**AGENDA
FARRAGUT MUNICIPAL PLANNING COMMISSION**

**October 18, 2018
7:00 p.m. Farragut Town Hall**

**MINUTES
FARRAGUT MUNICIPAL PLANNING COMMISSION**

September 20, 2018

Proposed Future Land Use Map Watt Road Corridor and Vicinity

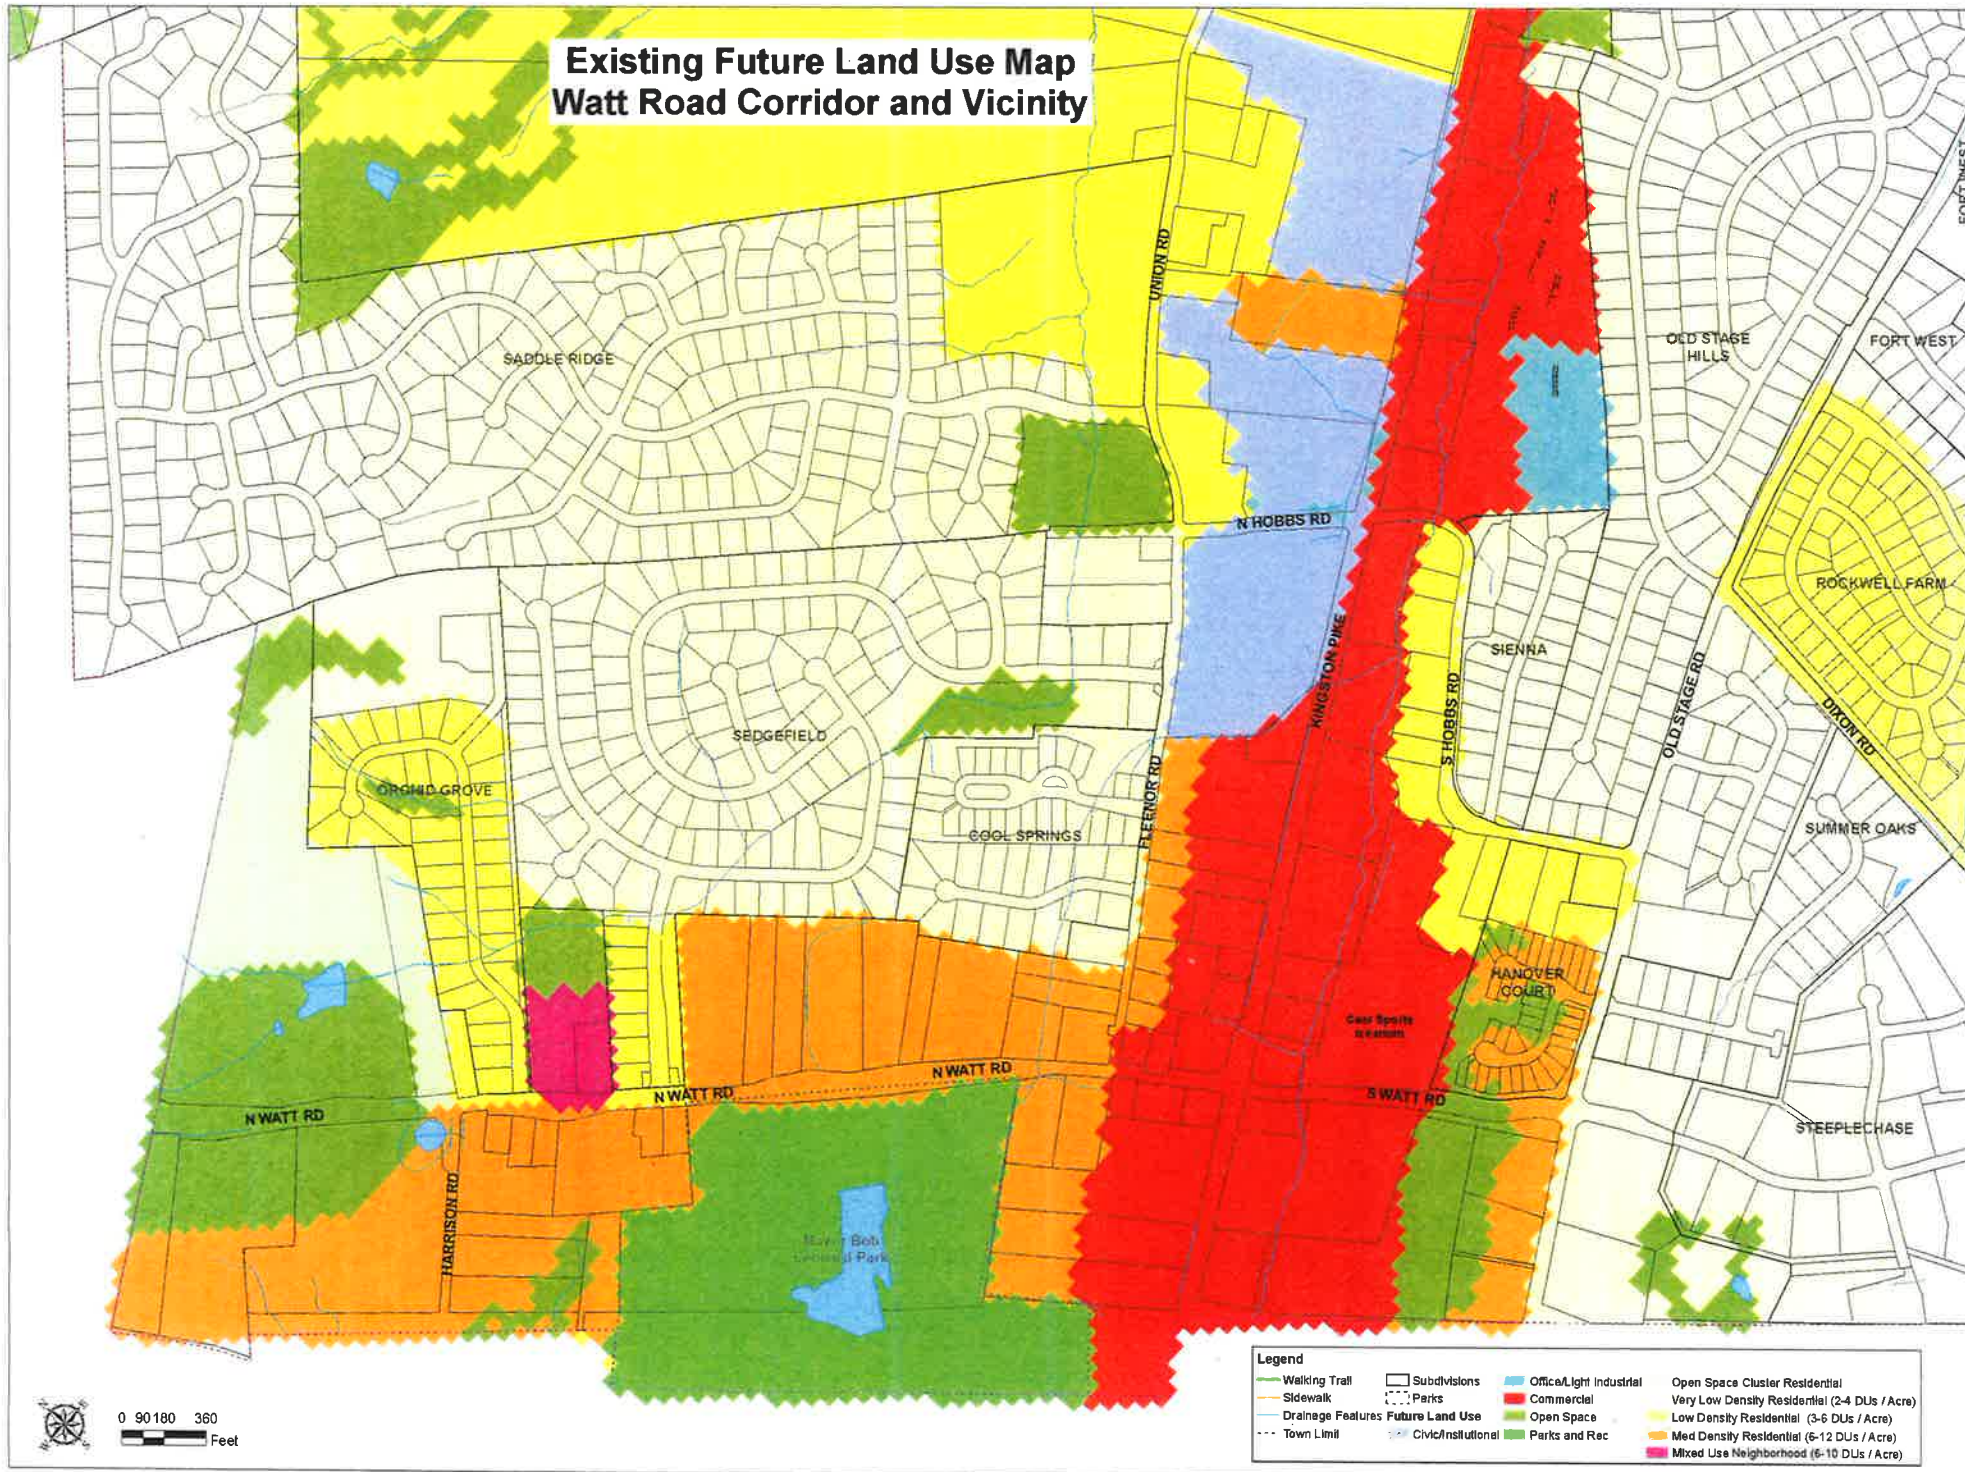
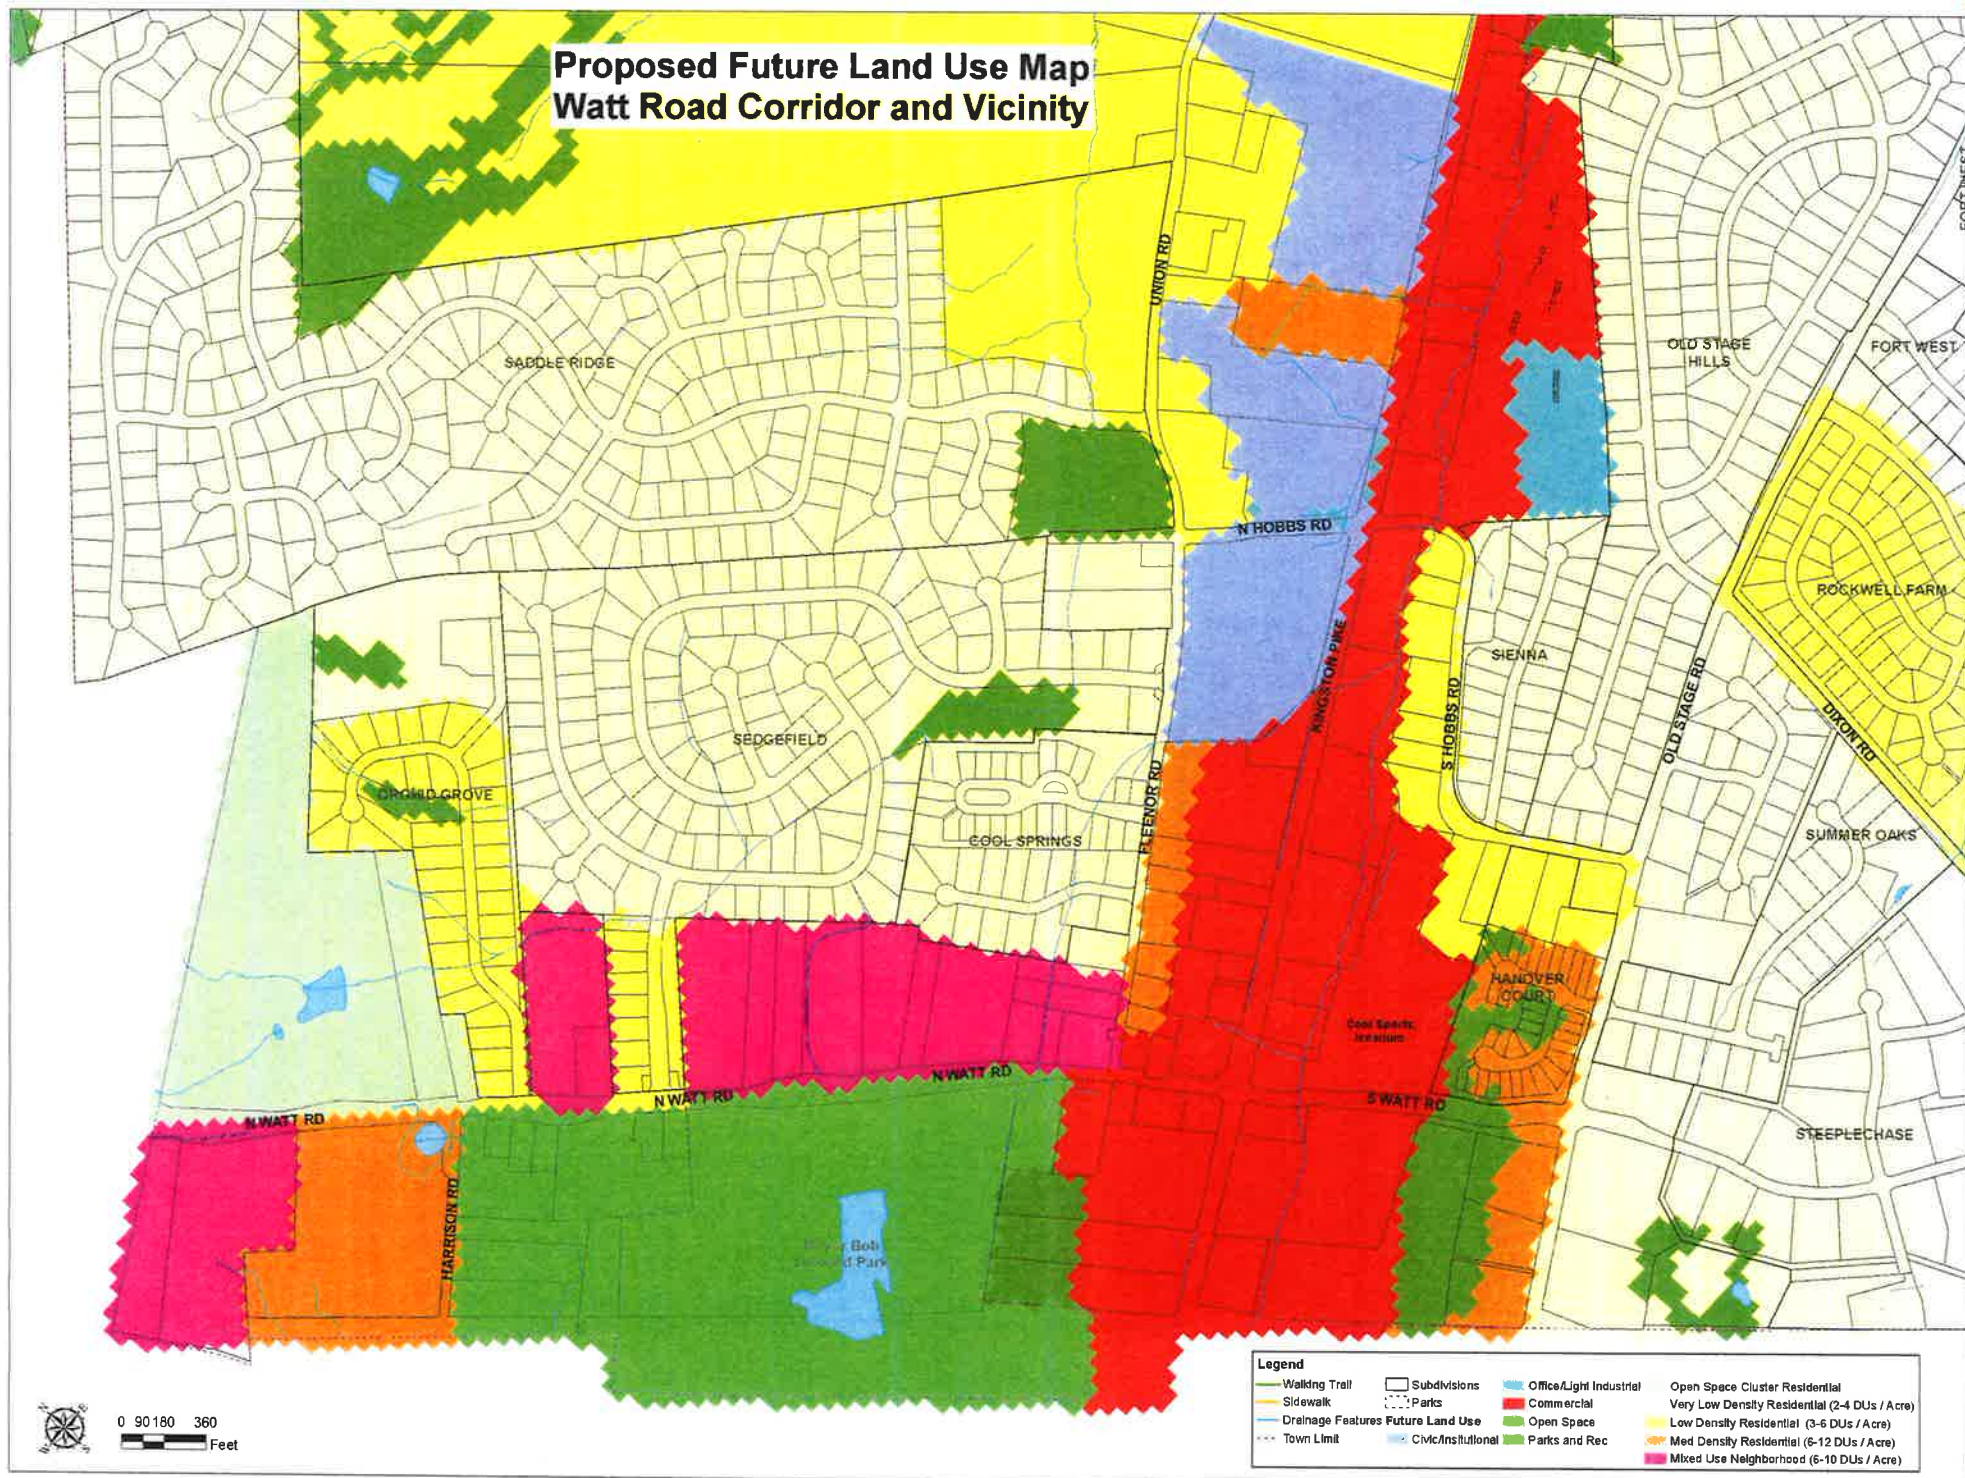
DISCUSSION: As a tool for helping to implement a desired land use vision (as expressed through the predominant public input received during the public engagement process) for the Watt Road corridor, the CLUPSC is proposing at this time to amend the future land use map as it applies to the Watt Road corridor. This will help to provide the Planning Commission with a mapped vision of the corridor that will guide land use decision making in the coming years. For example, if someone requests a rezoning along the Watt Road corridor, the Commission will use the future land use map to assess whether the request is consistent with the community's vision.

- Change the residential density in the Mixed-Use Neighborhood Land Use category from 6-10 dwelling units/acre to up to 8 dwelling units/acre. This would reflect the permitted density in the new Neighborhood/Convenience Commercial Zoning District;
- Change the density permitted in the Medium Density Residential Land Use category from 6-12 dwelling units/acre to 6-8 dwelling units/acre;
- Create a new land use category for High Density Residential and establish the density as 9-12 dwelling units/acre (NOTE: The Mixed-Use Town Center Land Use allows up to 15 dwelling units/acre and would not be the same as High Density Residential).

RECOMMENDATION: Included in your packet is a copy of the existing and proposed future land use map of the Watt Road corridor. Staff recommends approval of the proposed future land use map and the above noted text amendments to the CLUP.
